ARCHITECT'S SUPPLEMENTAL INSTRUCTIONS

PROJECT:	Residence at Heritage West New Development Andover, KS	Report No.	Three (3)
OWNER:	OPG Heritage West Partners, LLC Dan Maximuk 234 N. Santa Fe Ave, Suite A Salina, KS 67401	Date	April 30, 2025
CONTRACTOR:	MCP Build 3501 SW Fairlawn Rd., Suite 100 Topeka, KS 66614	Architect's Proj No.	24-3379
		Contract For:	General Construction Mechanical, Electrical

THE RESIDENCE AT HERATIGE WEST
NEW SENIOR LIVING FACILITY
ANDOVER, KANSAS

D UNIT 2D ACCESSIBLE W/ ROLL-IN SHOWER
2 BEDROOM - 1 BATH UNIT PLAN
1/4"=1'-0" 800 SF

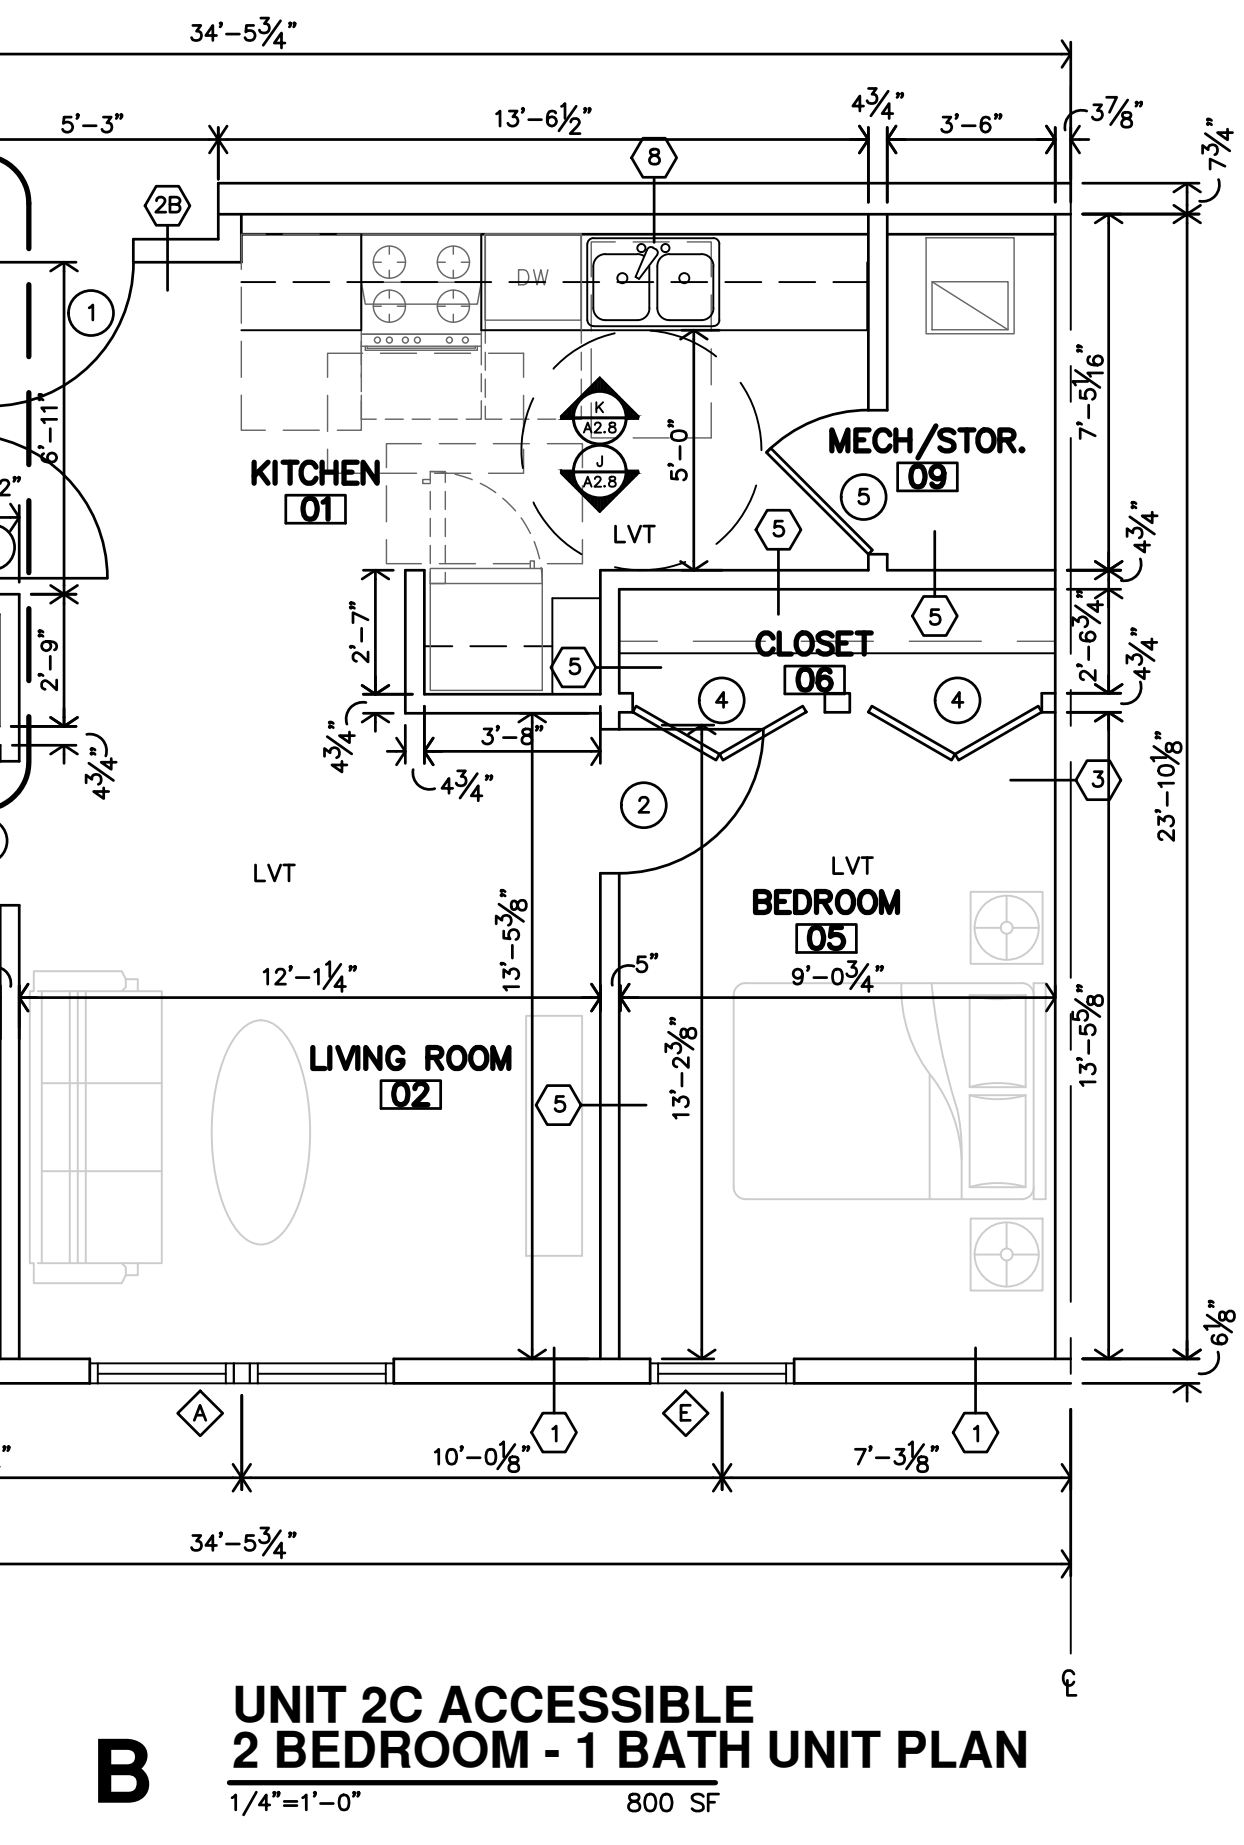
Per IBC Accessibility chapter 11. A roll-in shower unit is required. The current permitted set did not include a roll-in shower dwelling unit. Unit A11, Type 2D dwelling unit shall be a roll-in shower fully Accessible unit. Bath 03 within the dwelling unit has been amended to include a full 60" shower with ADA accessible roll over front edge. See FHA, ADA, ANSI diagrams and details for the requirements of a wheelchair access max. change in level surface. The shower hall include removable/folding seat. Plumbing plans have also been amended to include the pipe routing of differing type stacked units above.

Type 2D and 2B dwelling units must have a min. size storage closet with 16sf of clear space. The Mech/Stor. Closet 09 in these dwelling units has been increased to meet this KHRC requirement. The 2x stud wall type 5 has been moved towards the Kitchen area. Two sets of bifold doors will be required to close the opening.

3
P4.1
2 BEDROOM (UNITS 2D) ENLARGED DOMESTIC WATER PLAN
1/4" = 1'-0"

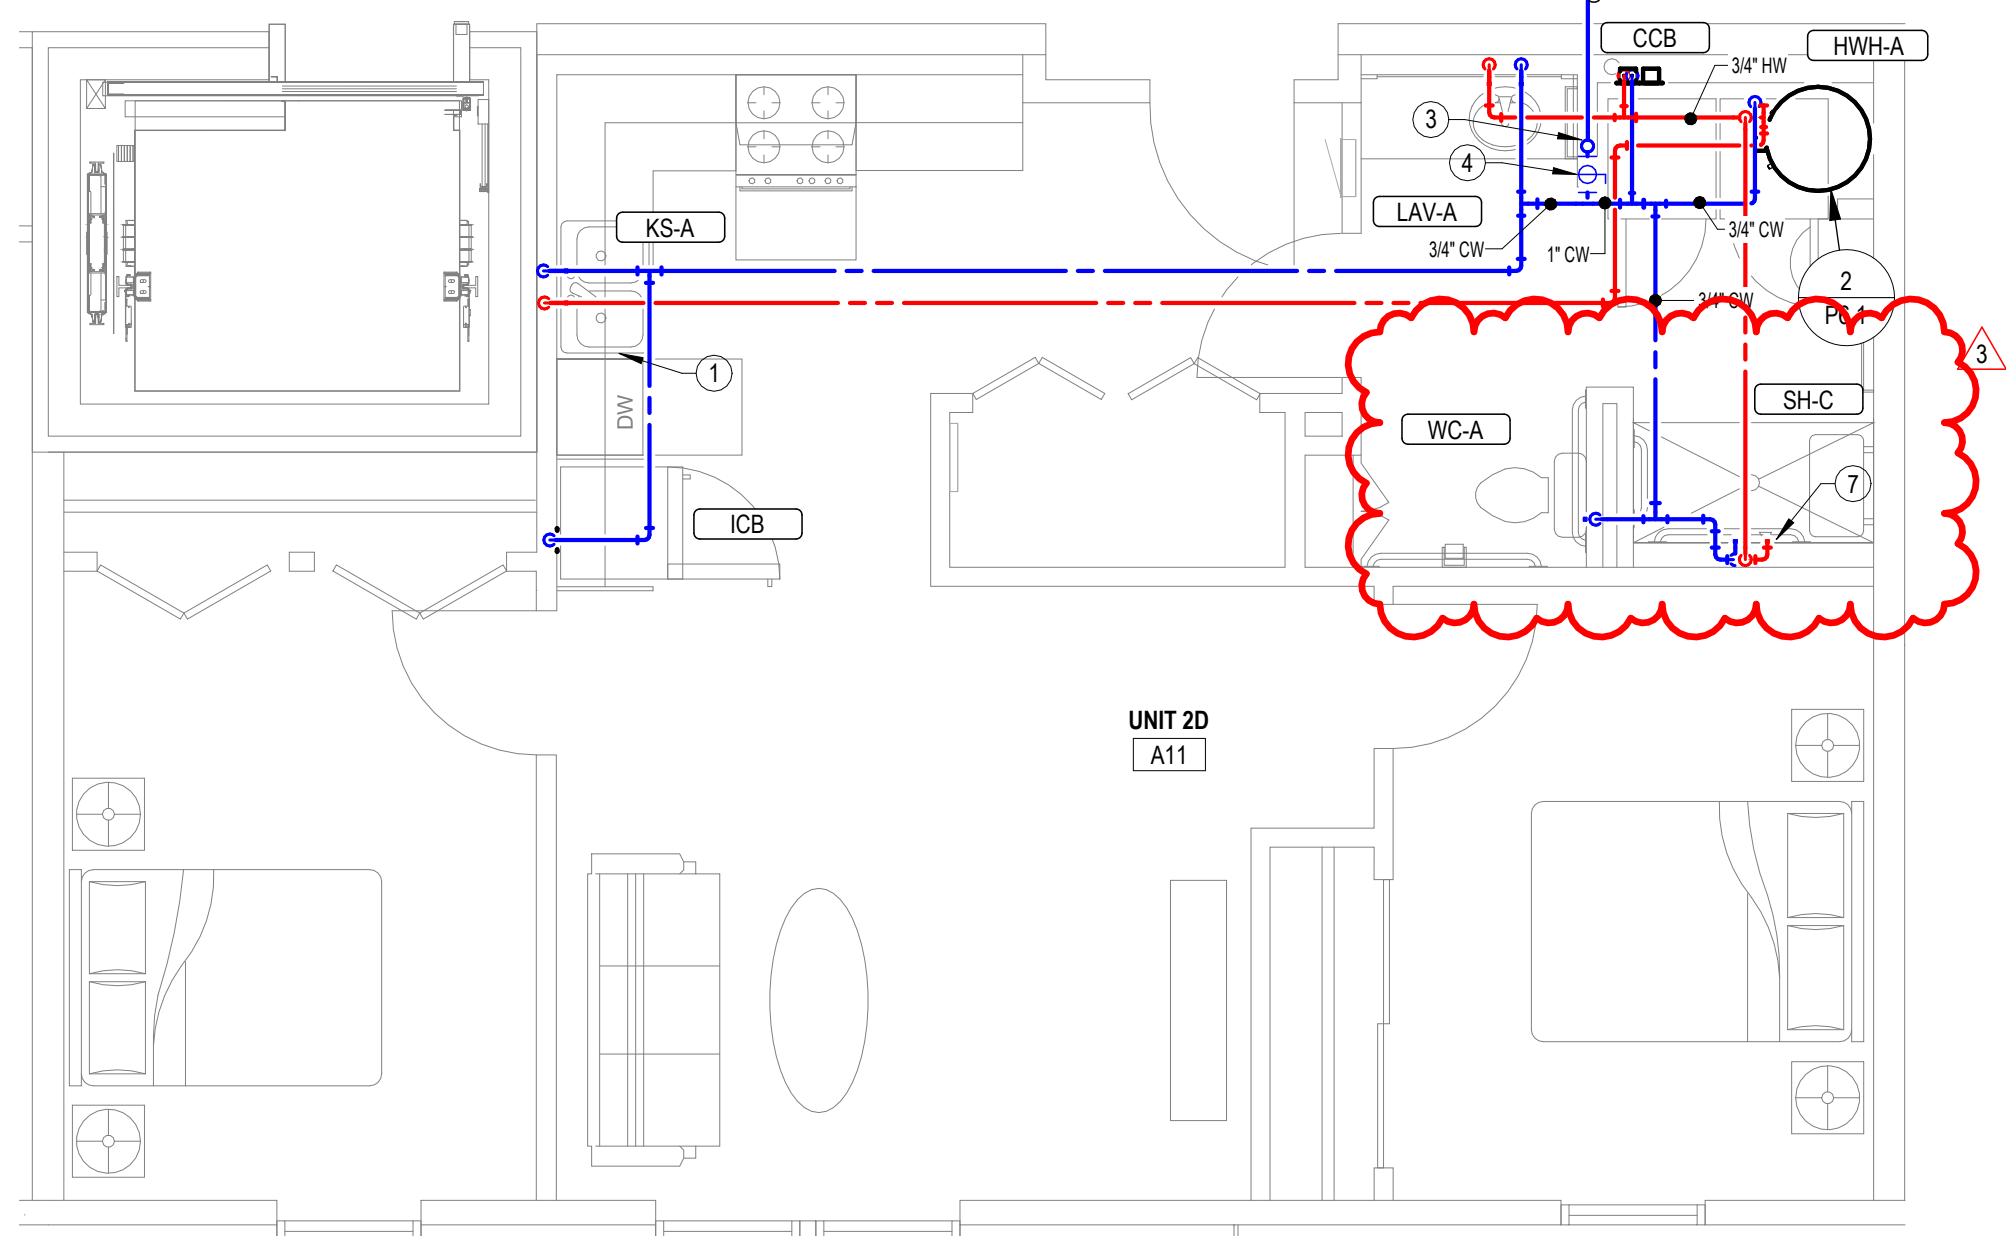
UNIT A11 SHALL BE PROVIDED WITH ACCESSIBLE FIXTURES. SEE P1.2 FOR FIXTURE TAGS.
